CORRECTIONS/AMENDMENTS TO THE DRAWINGS

REMARKS

The Examiner objected to the drawings due to non-consecutive numbering and some elements having no numbering. By this Amendment, corrected drawing sheets in the form of Replacement Sheets (as well as sheets indicating the corrections made) are submitted, which include corrected numberings, etc. The Replacement Sheets of drawings are believed to be in compliance with 37 CFR 1.121(d).

Figure 4

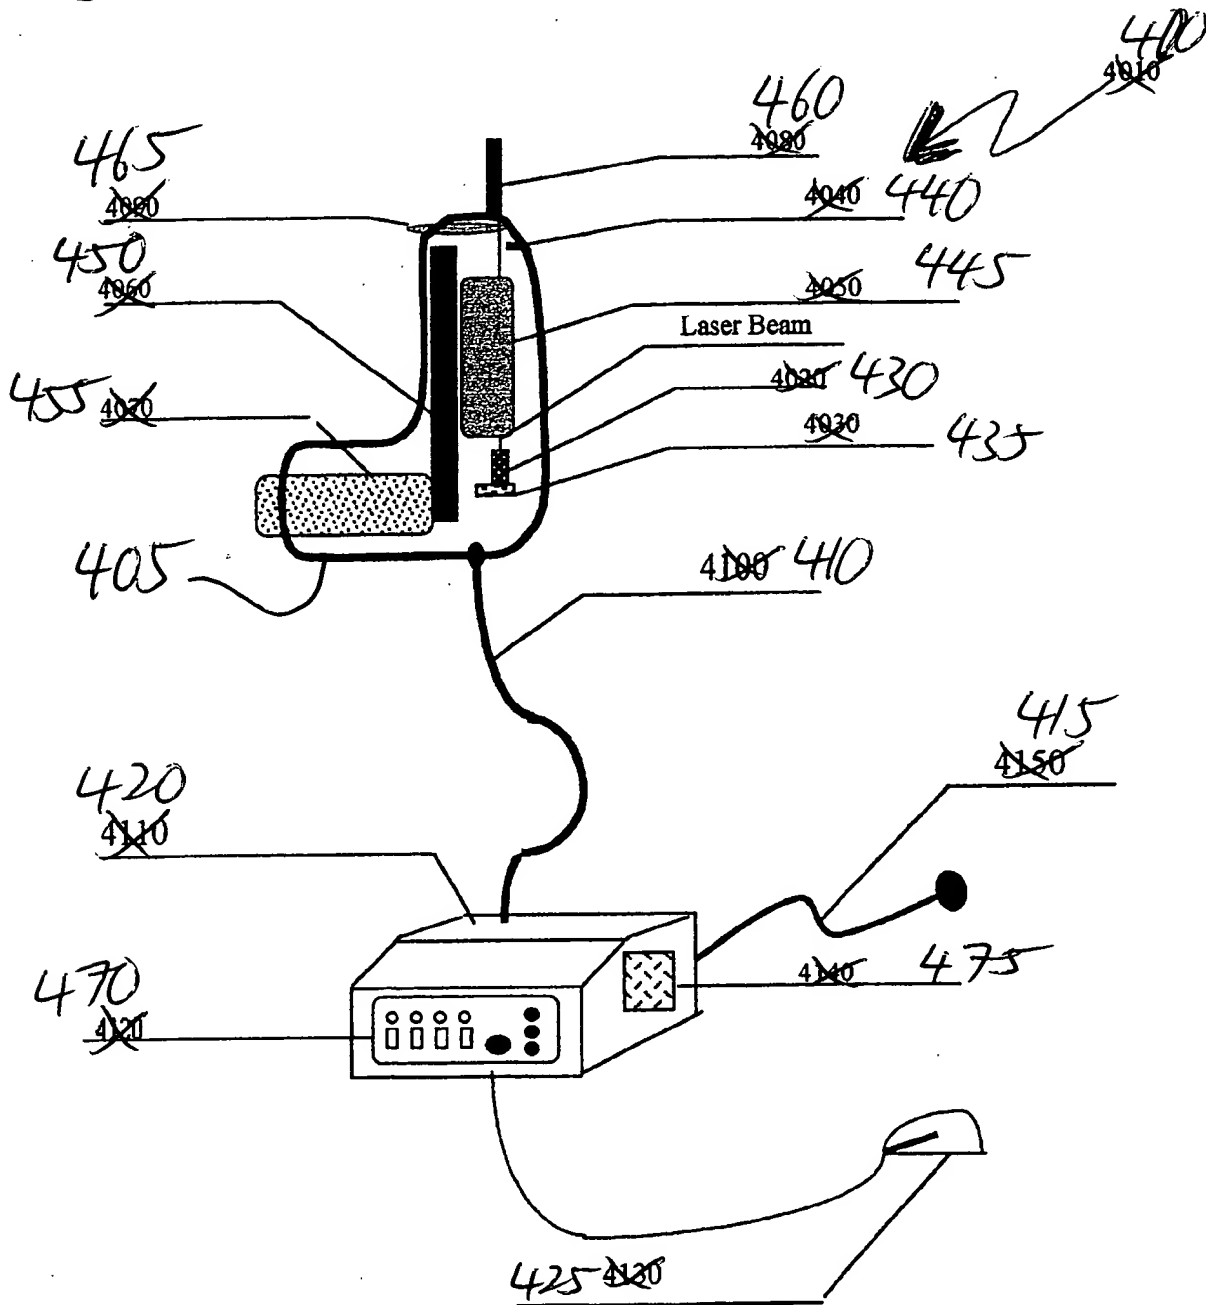
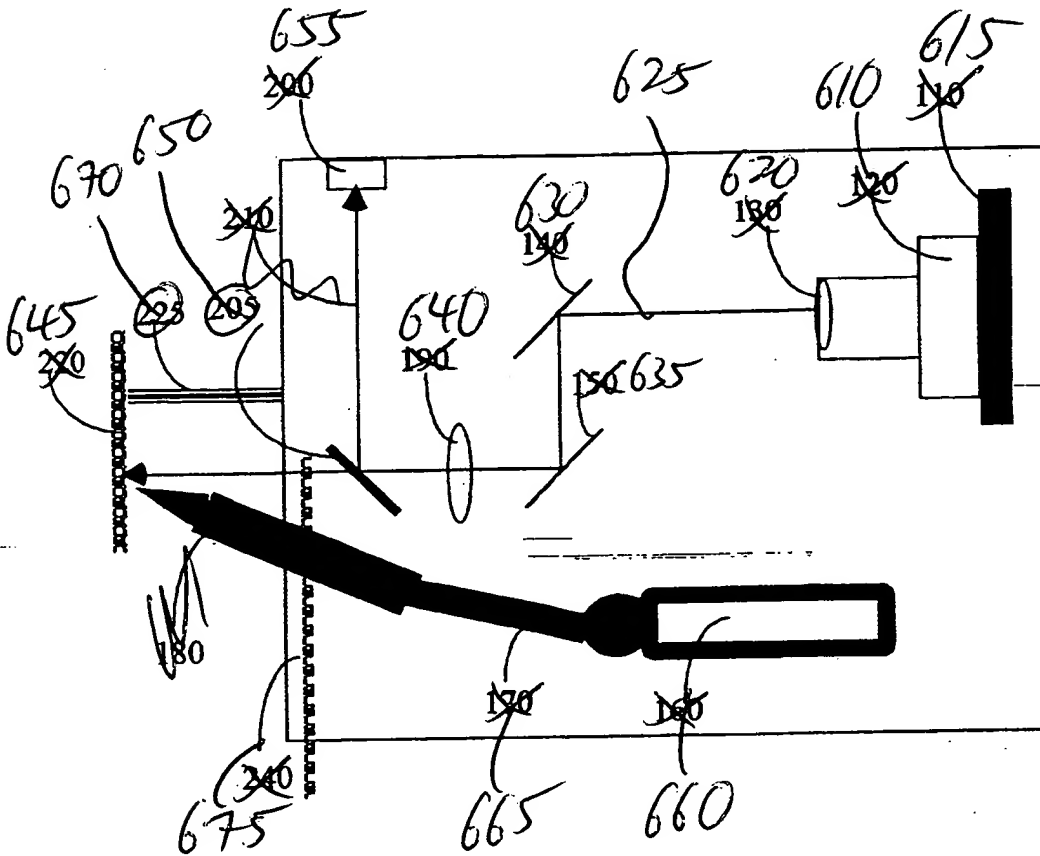
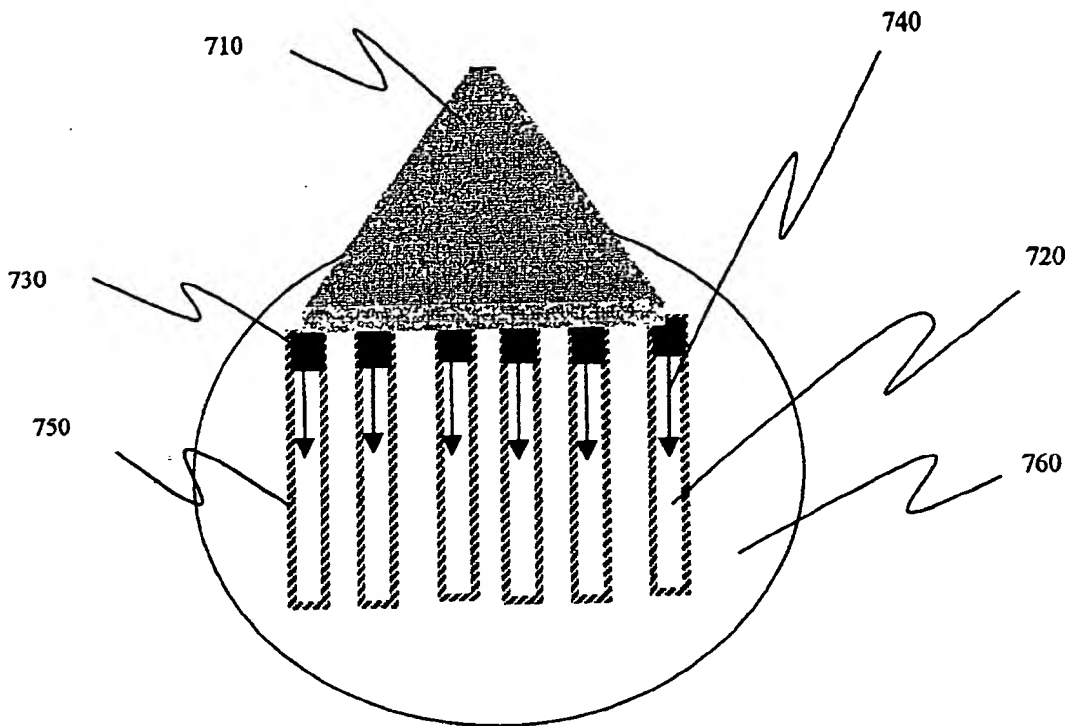
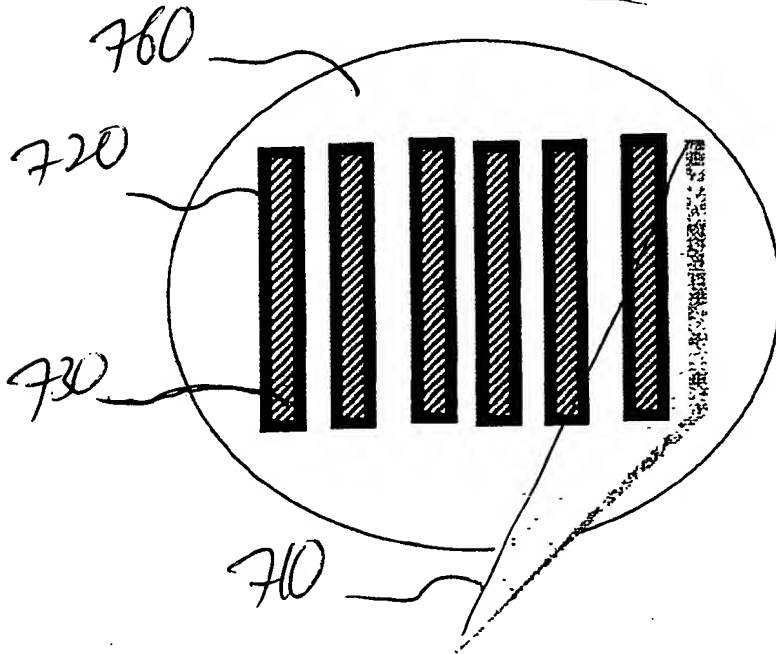
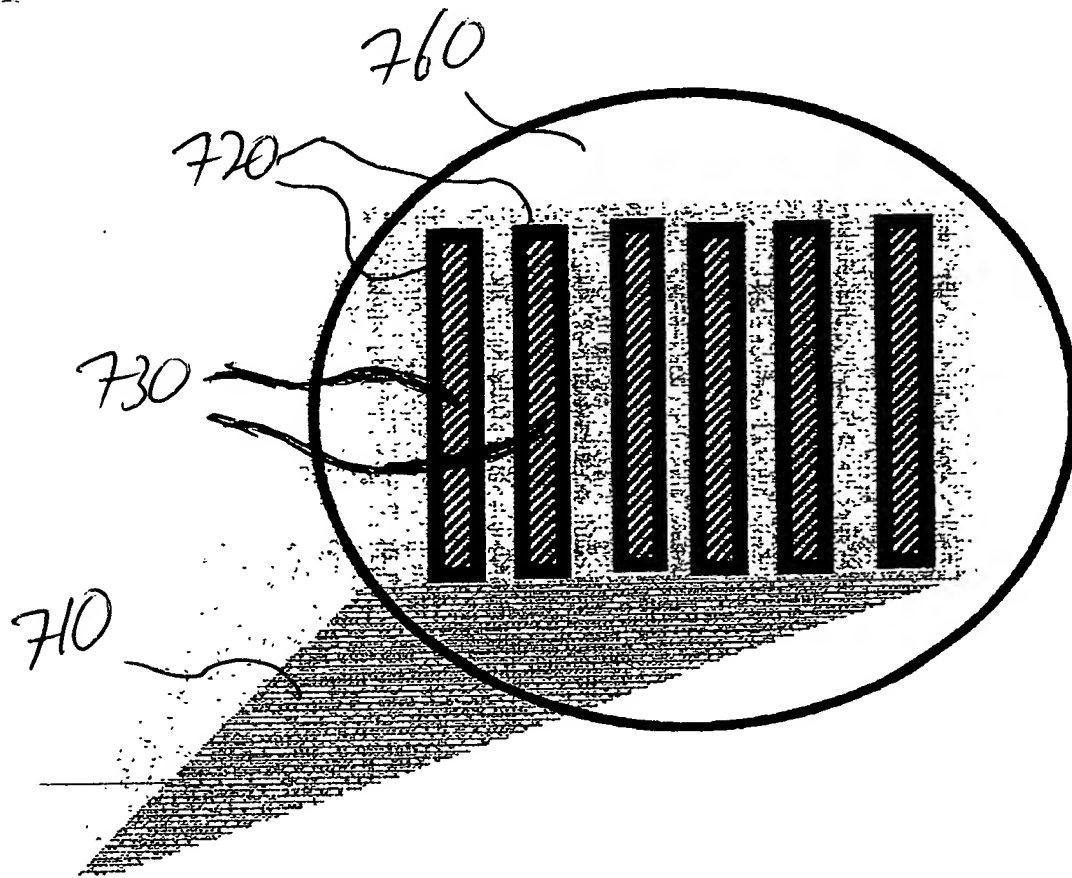
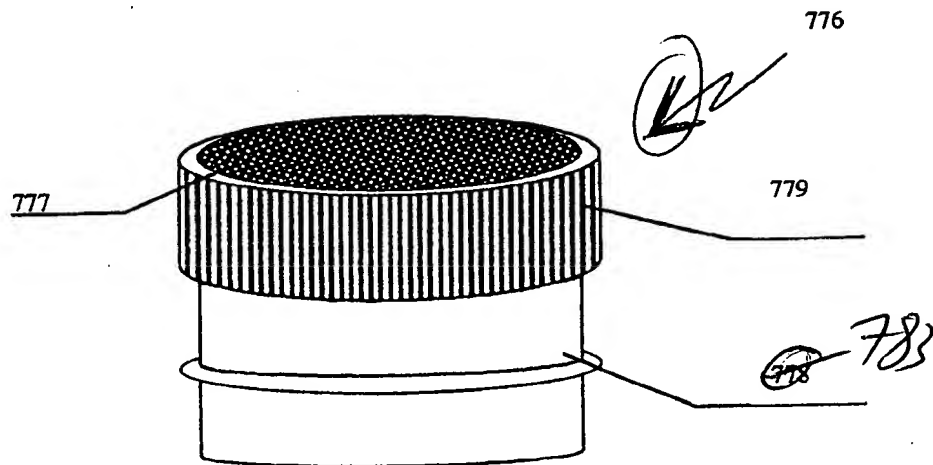
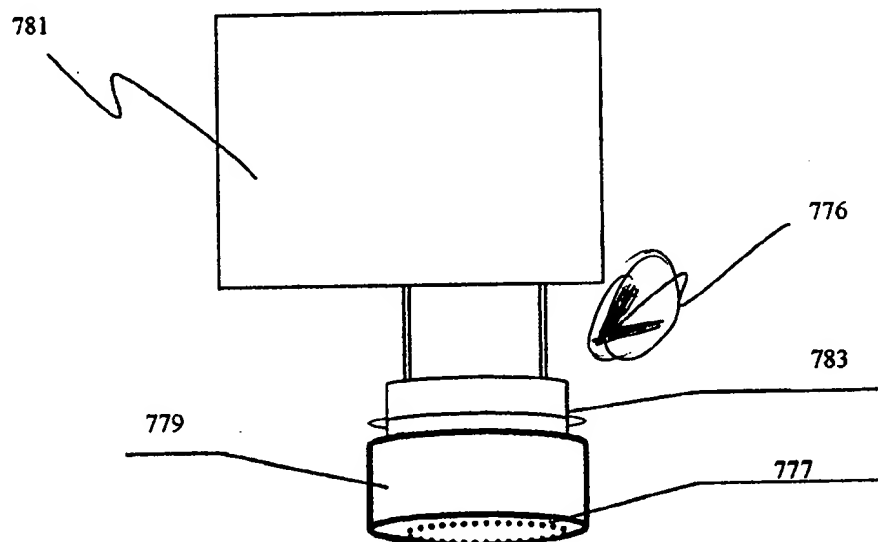
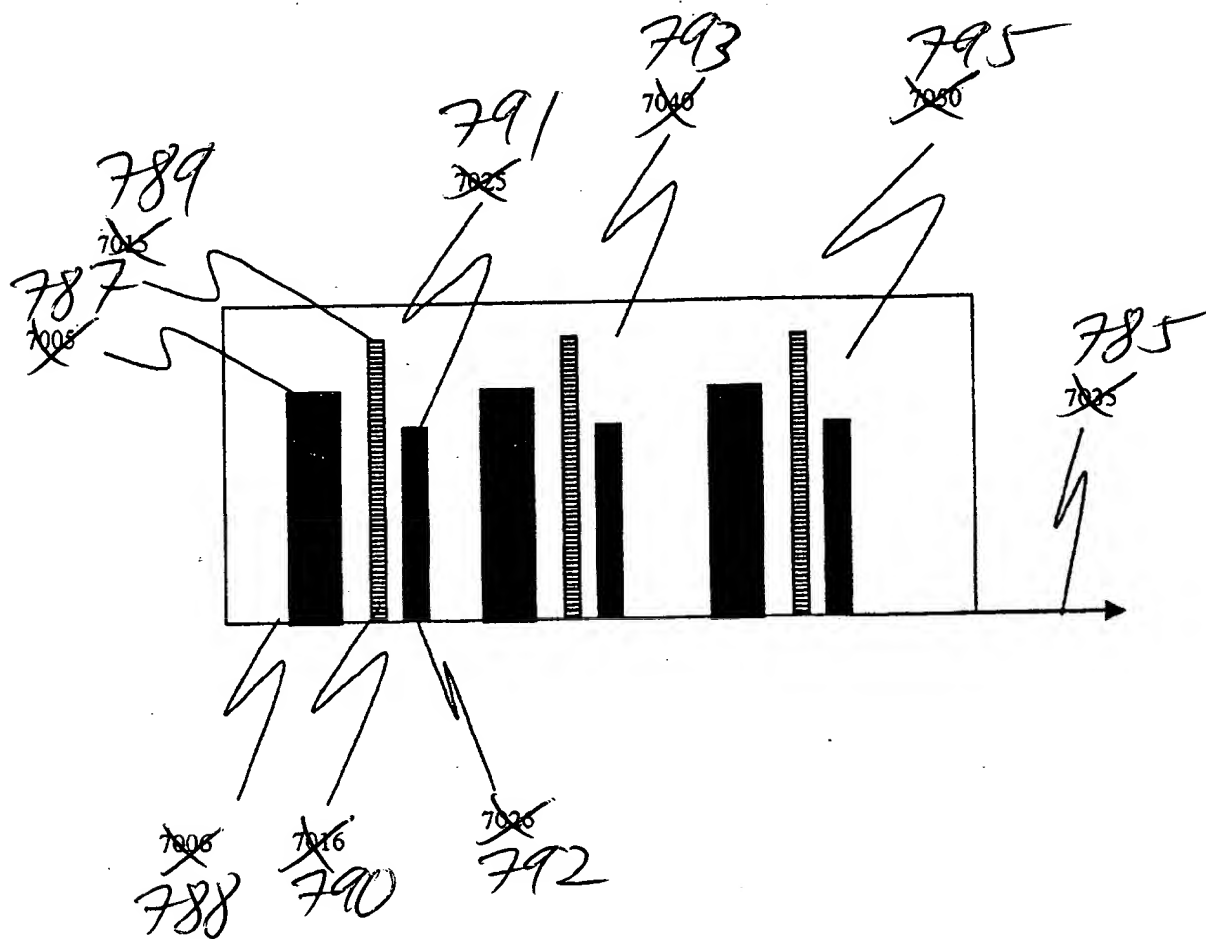
FIGS. 1A through 7F have been amended to change reference numbers for consistency with corresponding amendments to the reference numbers in the specification.

Figure 7C ~~the broad beam.~~
